MBNA
 A M E R I C ASM
 HALLMARK CENTER SITE HARDENING

OVERALL PLAN

C1.0

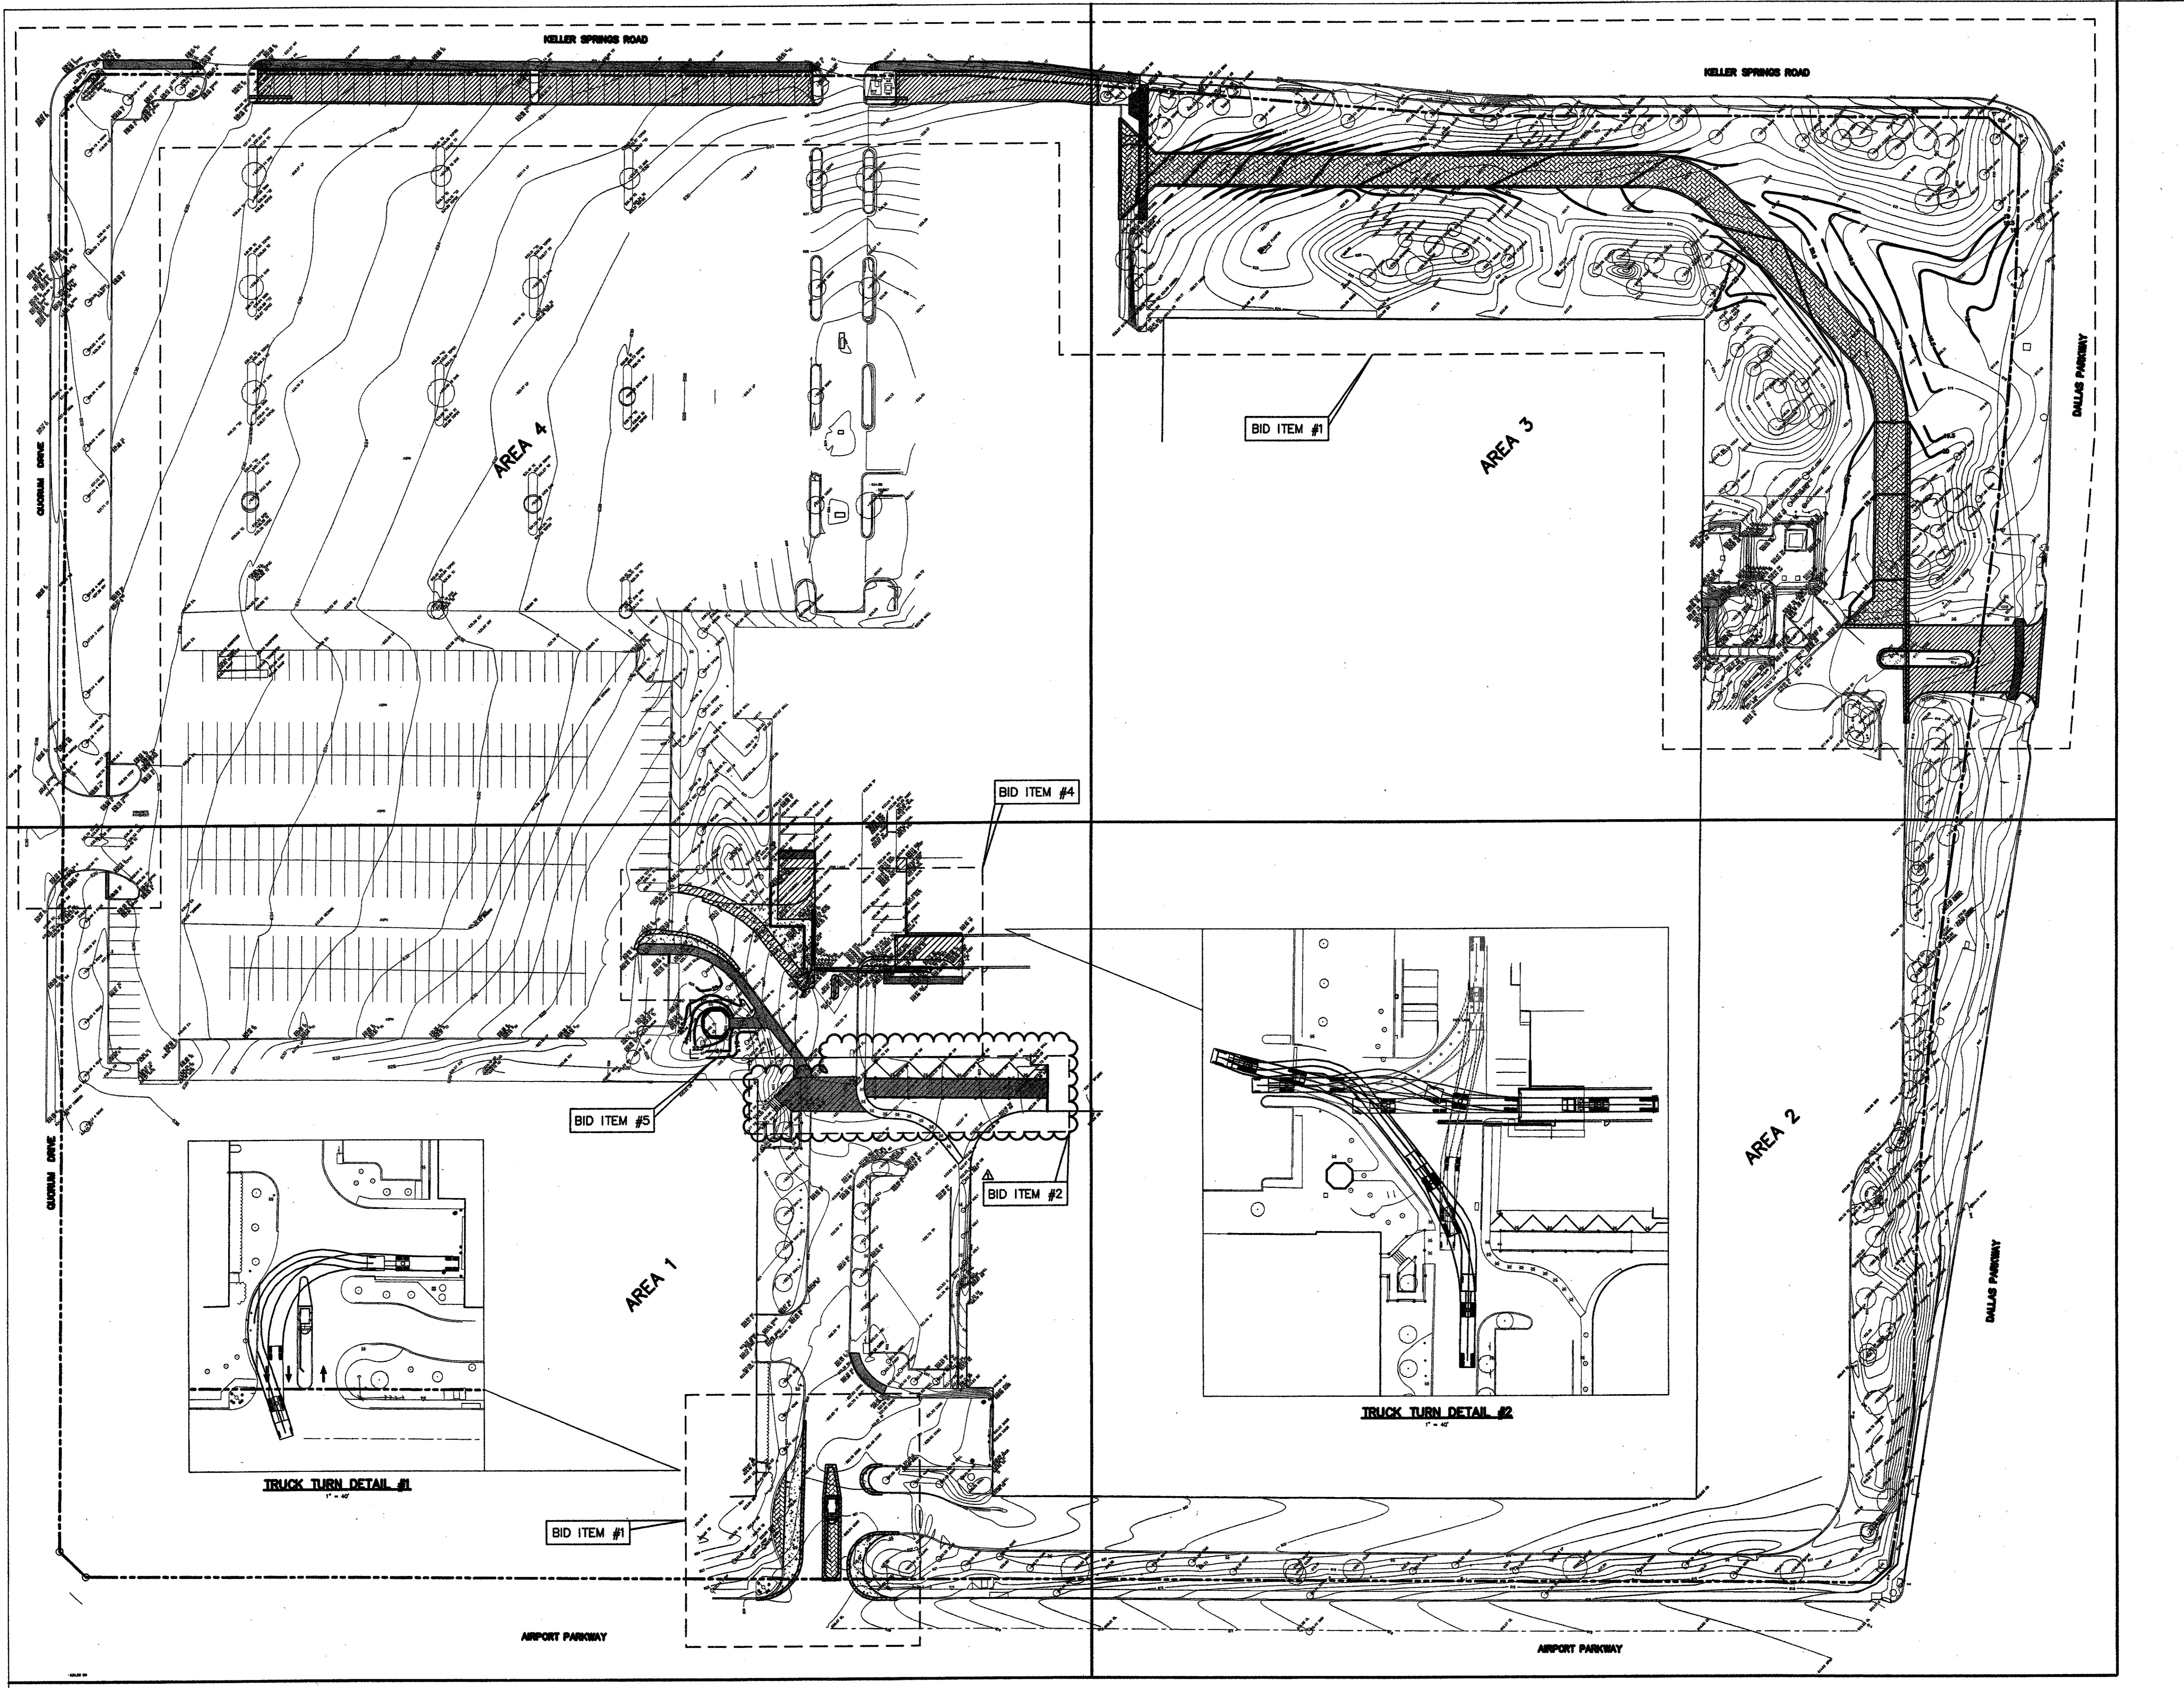
- 1) Obtain ROW Excavation Permit from: Town of Addison Public Works Dept. 16801 Westgrove Rd. Addison, TX 75001
- 2) Note changes to sidewalk + curb Specs. Also SEE ATTACHED
- 3) Curb expansion "bars" are to be placed at all locations where new curb abuts existing.
